PROJECT: CDDP24-03045
ADDRESS: 430 LEGACY DR (193010029)
APPLICATION TITLE: Planning and Site Development Review
PROJECT NUMBER: 1525879

TO: Syd Sotoodeh, Senior Planner, Department of Conservation and Development
FROM: Larry Gossett, Senior Civil Engineer, Engineering Services Division
SUBJECT: **PERMIT DP24-3045**
30-DAY COMMENTS – INCOMPLETE
(James/Legacy Drive/Alamo/APN 193-010-029)
FILE: **DP24-3045**

TO: Syd Sotoodeh, Planner, Department of Conservation and Development
FROM: Larry Theis, Engineering Services Division – Consultant Engineer 
SUBJECT: **DEVELOPMENT PLAN CDDP24-03045**
STAFF REPORT & RECOMMENDED CONDITIONS OF APPROVAL
(Jonathan James (Applicant) - New Single Family Residence at 430 Legacy Drive – Alamo area APN 193-010-029)
FILE: **CDDP24-03045**

Subject: Geologic Peer Review/ COA Compliance Review
CDDP24-03045 / Lot #7 of SD-7744 (Legacy Drive)
COA #14 of CDDP01-03061 / APN 193-019-029
Clyde Miles Construction (owner & applicant)
Alamo Area, Contra Costa County
DMA Project 3010.25

GRADING AND DRAINAGE PLAN

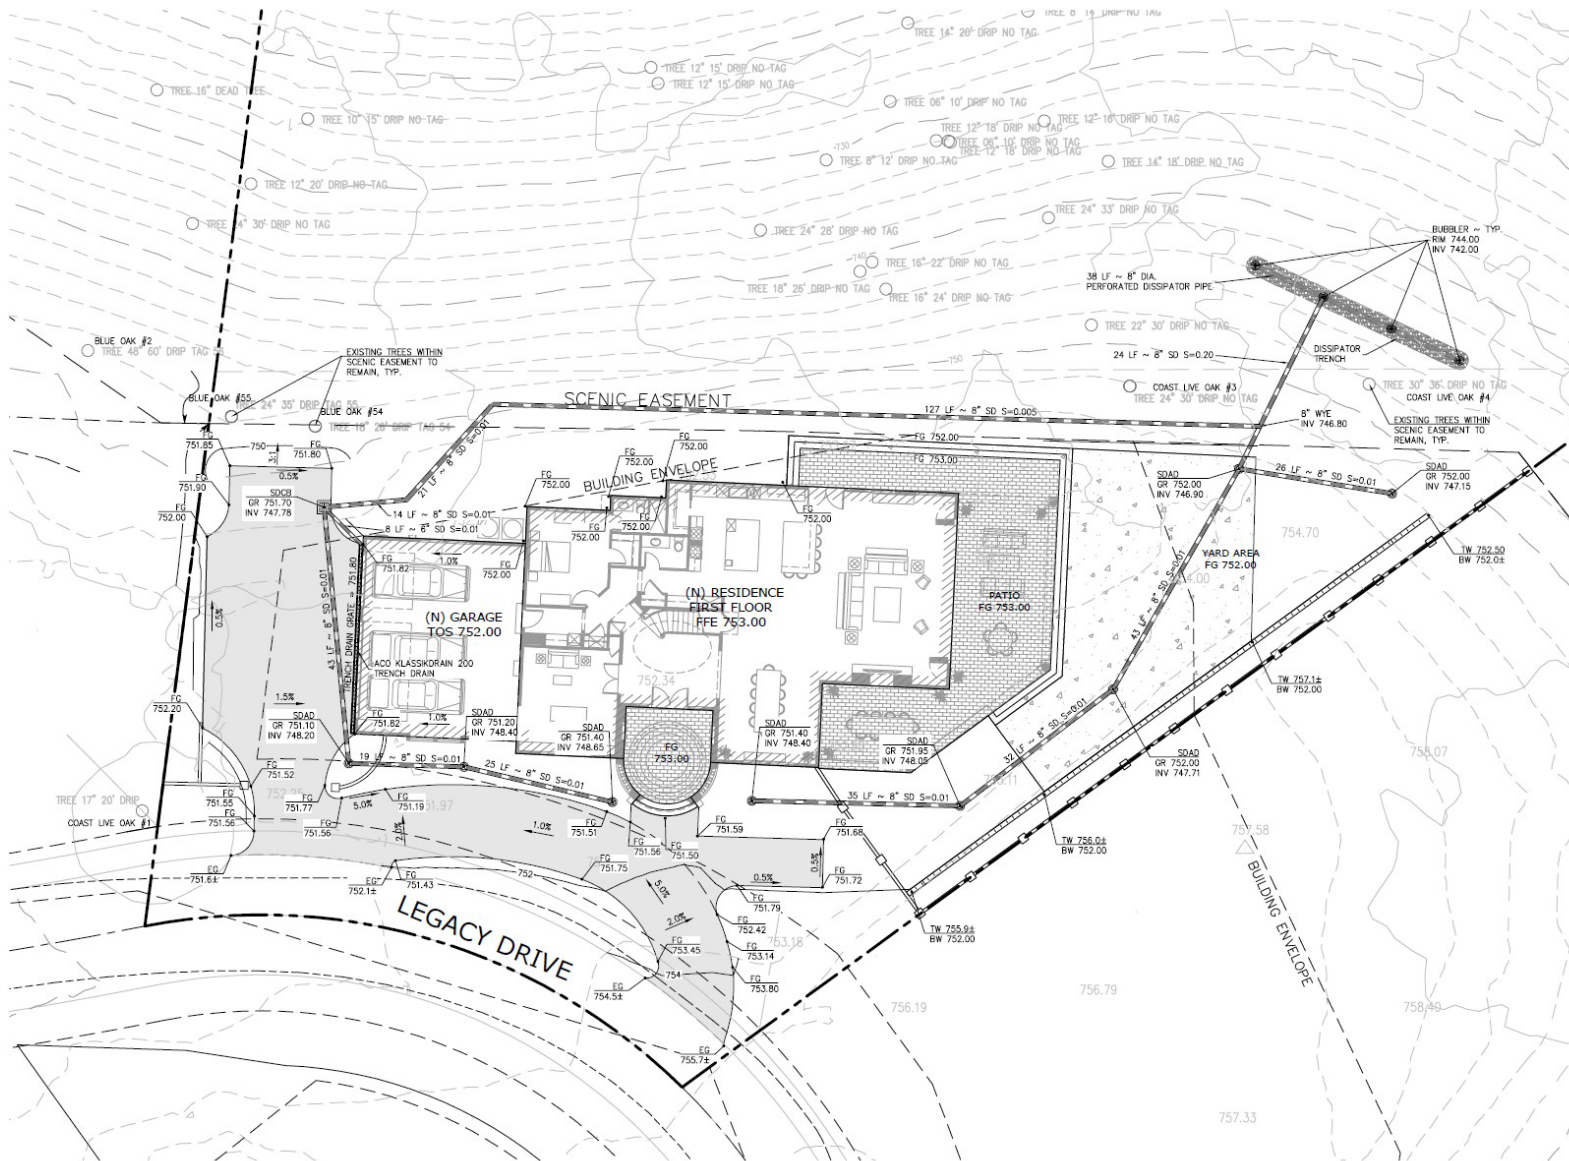
- This recommendation is based upon the revised plans received by the County on February 14, 2025 and upon a further revised Grading and Drainage Plan received by AIA from the applicant on March 20, 2025. A copy of the revised Grading & Drainage plan is enclosed.
- We understand from the applicant that the arborist's report is being revised. The revised report should include specific measures to prevent damaging or cutting the roots of nearby trees when trenching for the underground storm drain lines. A certified arborist should be present at all times that storm drain work is occurring within the dripline of any code-protected tree.

- While the recently provided revised Grading and Drainage Plan is a substantial improvement on prior versions of the plan, trenching for underground storm drainage lines still comes within 4 to 5 feet of the trunks of 24" Coast Live Oak

Tree #3 and 10 to 12 feet of 30" Coast Live Oak Tree #4, as does the proposed dissipator trench.
